Probabilistic Risk Assessment Input to Decommissioning Requirements

NRC/Industry/Public Workshop

Risk-Informed Basis for
Decommissioning Exemption
Guidance

July 15-16, 1999

Figure 3.3-1 Comparison of Spent Fuel Time Line for Loss of Cooling Events

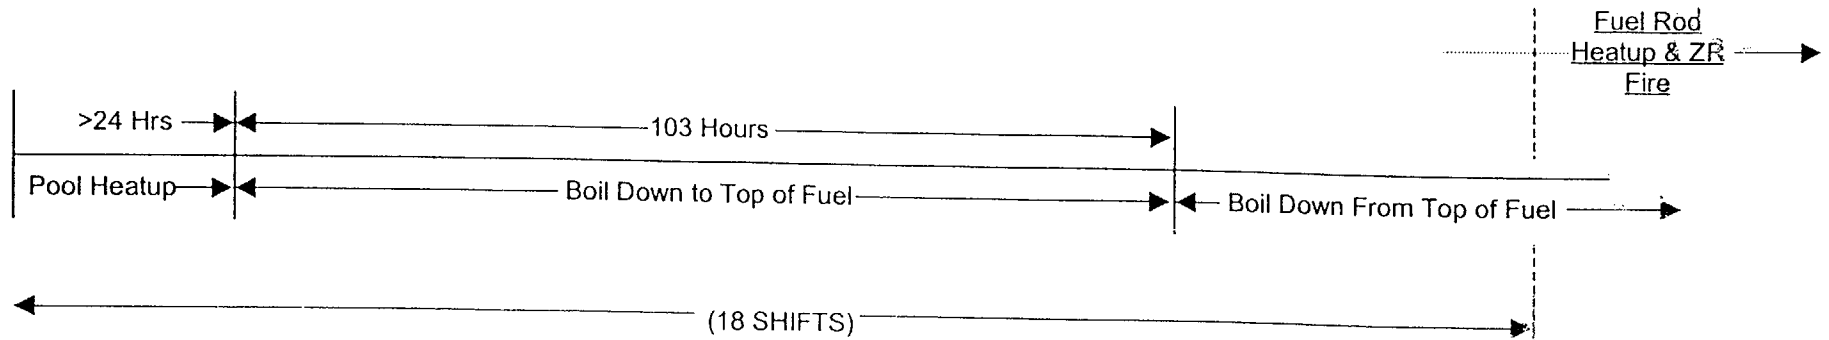
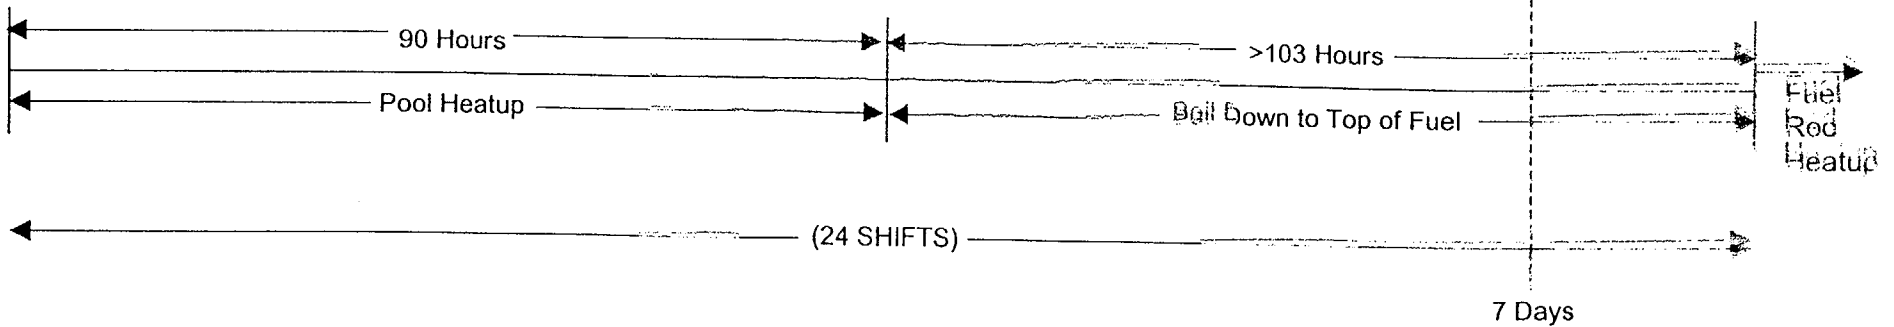
DRAFT NUREG

REALISTIC ESTIMATE

Table 2.1-1
KEY TEMPERATURES IN THE ASSESSMENT OF
ZIRCONIUM IGNITION & RUNAWAY OXIDATION

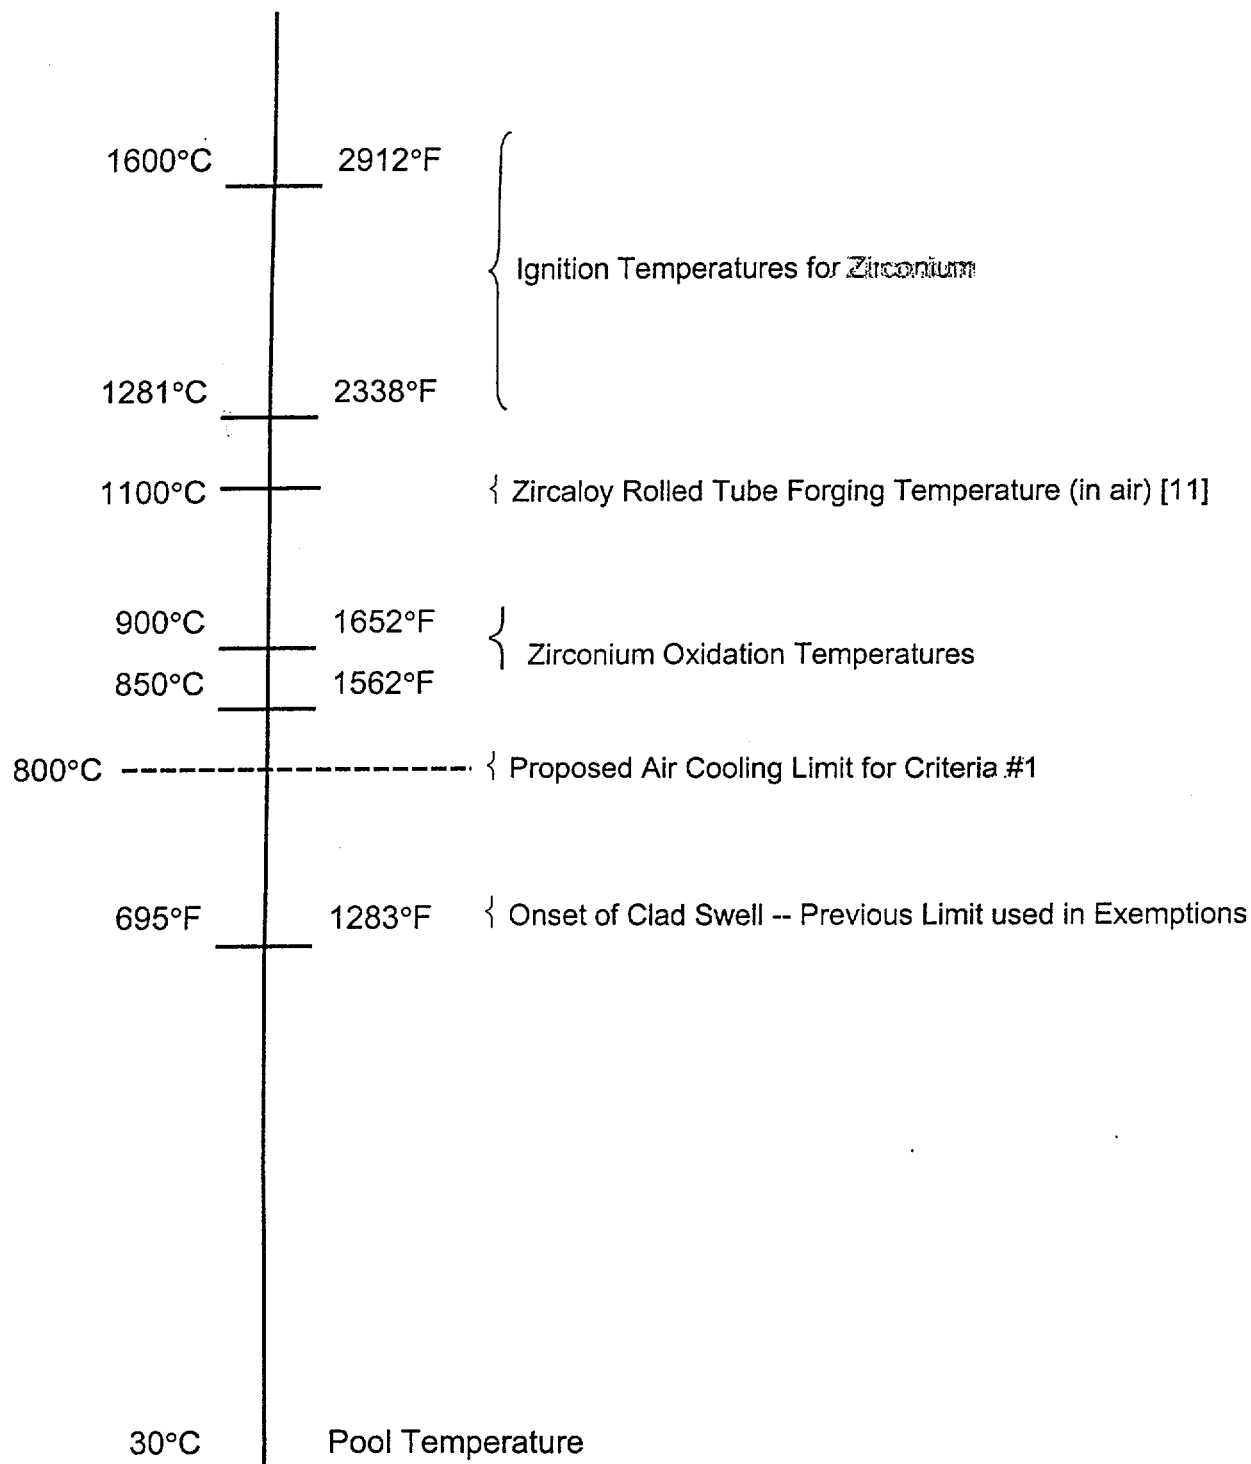
Ignition Temperature (Section 2.1.1)

“The oxidation temperature reported by SNL was the onset of oxidation, but not the temperature at which rapid, runaway oxidation or ignition occurs”

Nevertheless 800°C is used despite references indicating that Zircaloy ignition is >1600°C.

DISTRIBUTION OF CONTRIBUTORS TO FREQUENCY OF FUEL UNCOVERY (FFU) FROM
DRAFT NUREG
(Case I Total FFU=1.2E-5/yr)

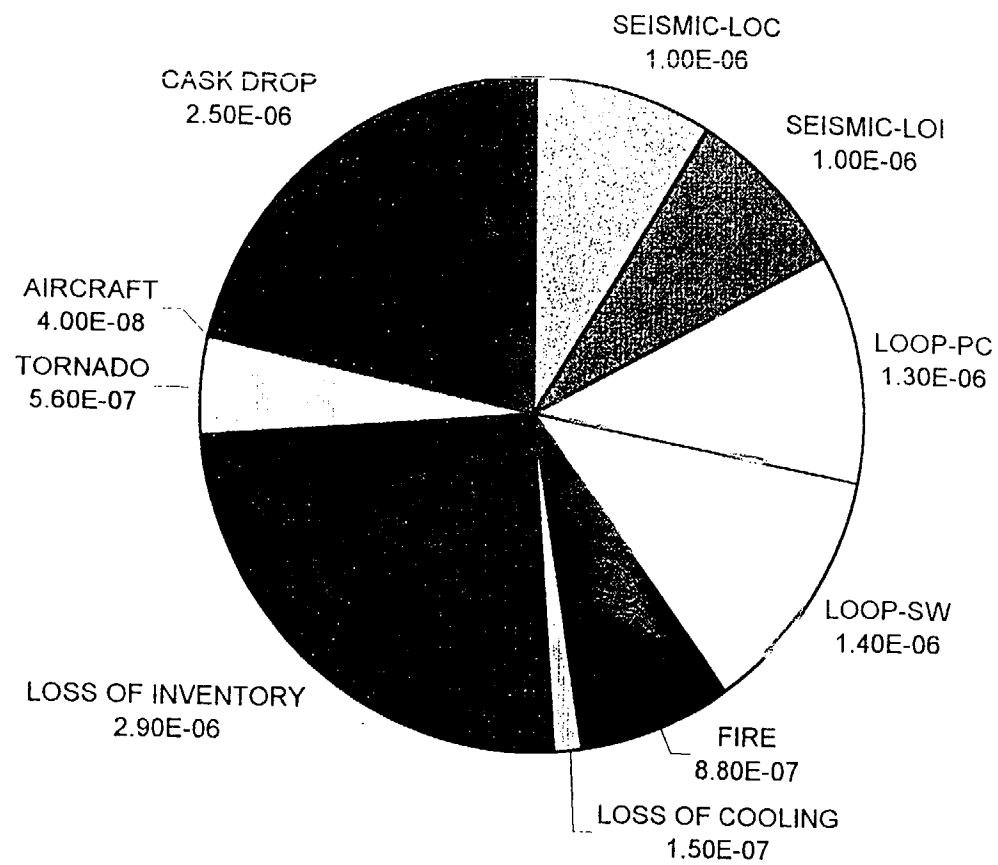
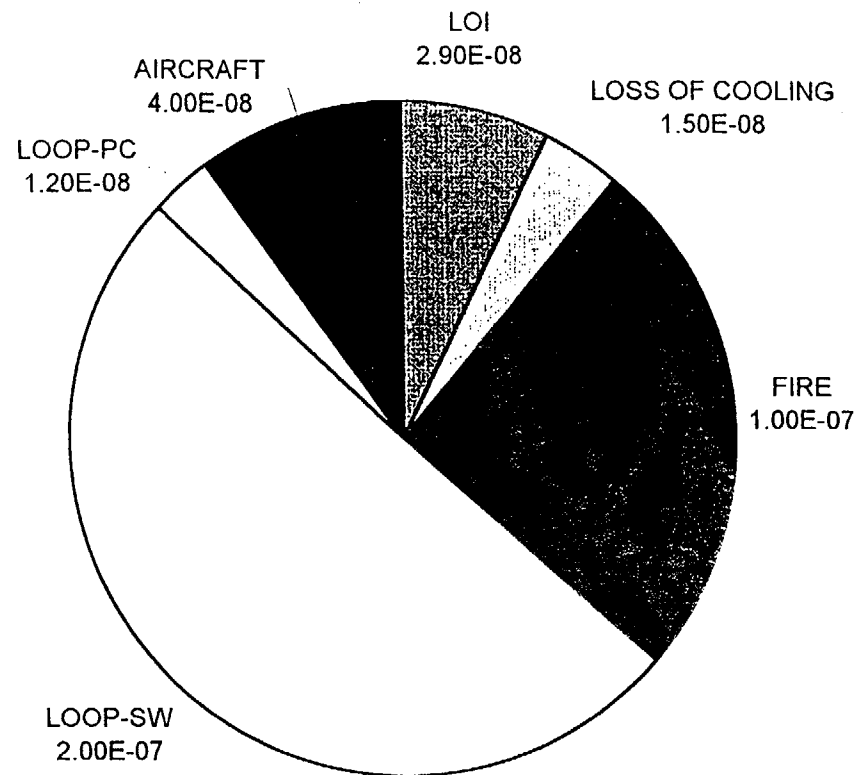
**DISTRIBUTION OF CONTRIBUTORS TO FREQUENCY OF FUEL UNCOVERY (FFU) FROM
BEST ESTIMATE CALCULATION
(Case I Total FFU=4E-7/yr)**

No seismic
